# Technical Notice

**Product Name:** FRK series

This notice is to inform you of changes to the FRK12/15/17-R10 series.

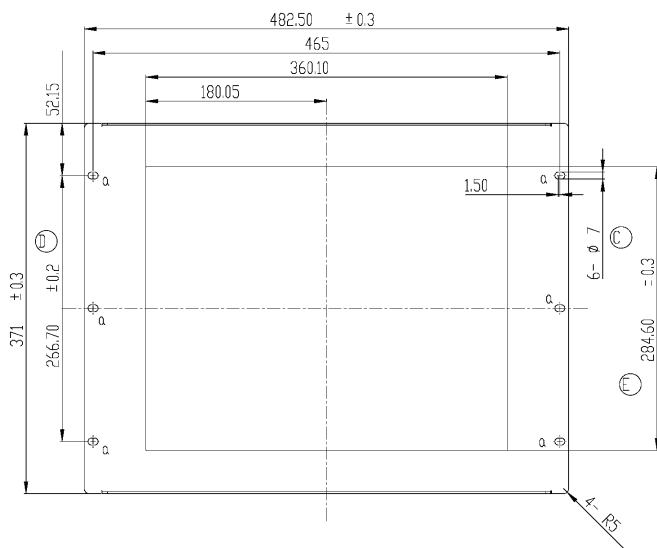
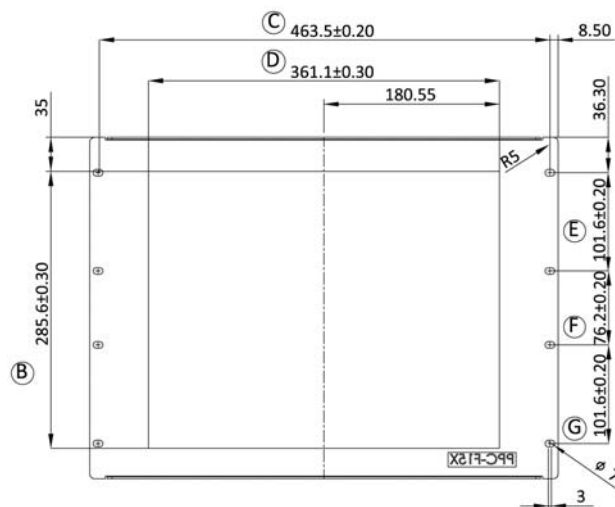
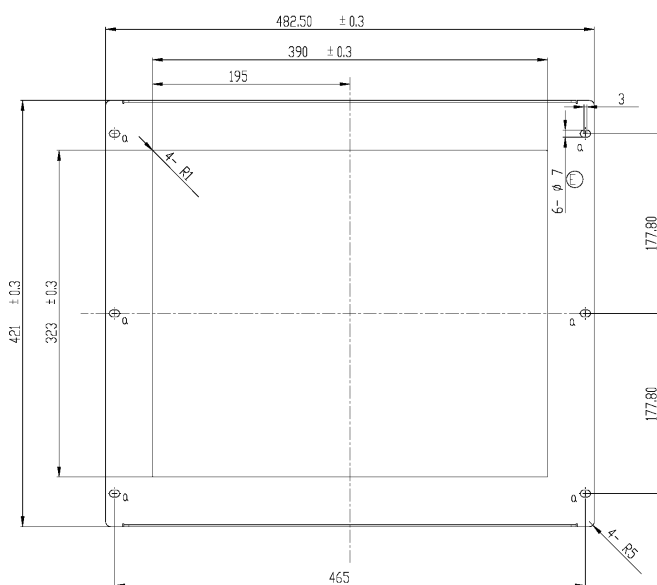
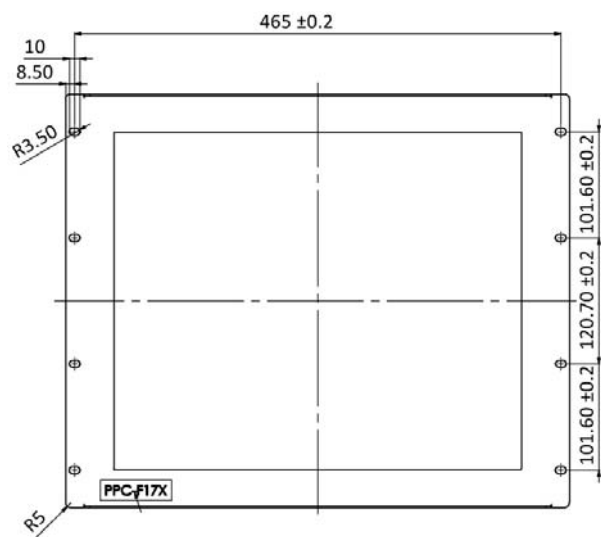
Modified mechanism parts

Modified mechanism parts to meet the EIA-310-D specification.

Old Version	New Version
41020-0389C2-00-RS (for FRK12-R10)	41020-0389C2-01-RS
